# OVERALL MASTER DEVELOPMENT PLAN OF WOODLAKE PARK

INFORMATION SHEET FOR  
 PRELIMINARY OVERLAY AREA DEVELOPMENT PLAN  
 (P.O.A.D.P.)

Re: Woodlake Park  Preliminary Plan  
 P.O.A.D.P.  
File #: 84-20-59-64 (Revised)  
**3-1-84**

City of San Antonio  
 No: Woodlake Park  
 File # 84-20-59-64

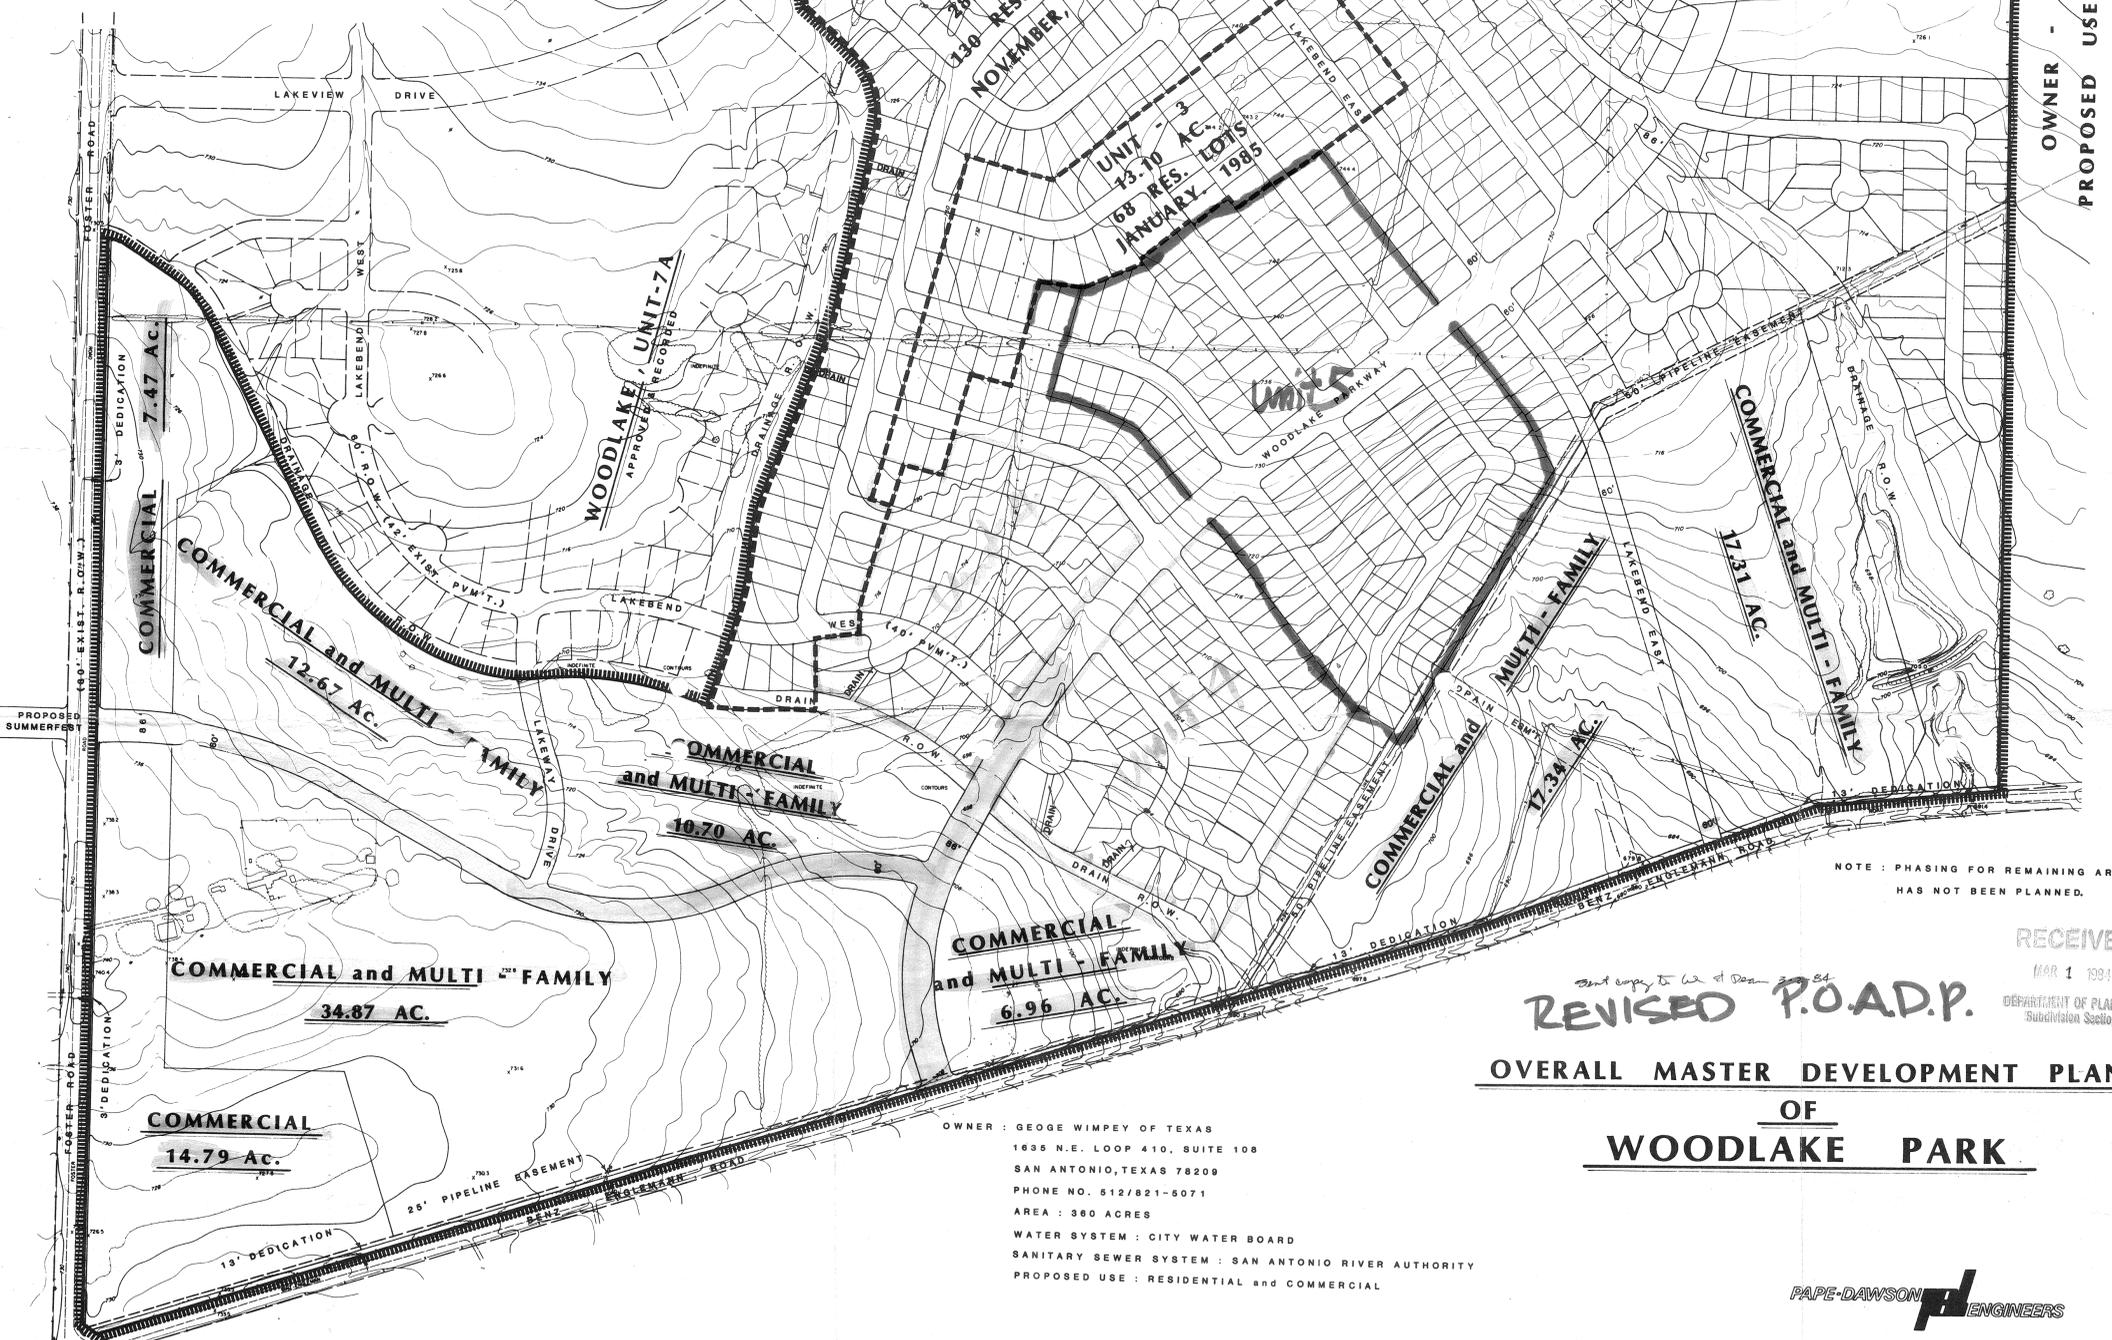
Spoke to George P. 1-16-84 and requested additional info  
 (1) existing R.O.W. width at Foster, Benz Engelmann & Lake Jean.  
 (2) planned paving width for all 60 rows  
 (3) entry to Sunrise build. at Foster.  
 (4) provide updated completion dates for project.

Discussed with required info 1-13-84 copy to all & Papan  
 1-24-84 P.O.A.D.P. committee met to review Woodlake Park. All, suggest  
 that defer the review pending word from George Dawson regarding the possible realignment  
 of Woodlake Parkway into Benz Engelmann. He said we could expect some word by

Comments: It is recommended that a portion of Woodlake Parkway be realigned. The street alignment depicted on the attached POADP will then be consistent with the proposed amendments to the Major Thoroughfare Plan. Additionally, the 86' street section west of the new alignment can be downgraded to a 60' collector.

Comments: This is to acknowledge receipt of the revised POADP. Said plan reflects the realignment of Woodlake Parkway and the downgrading of the 86' street section west of the new alignment as recommended by staff. In this regard, staff poses no objection to the amendment as submitted.
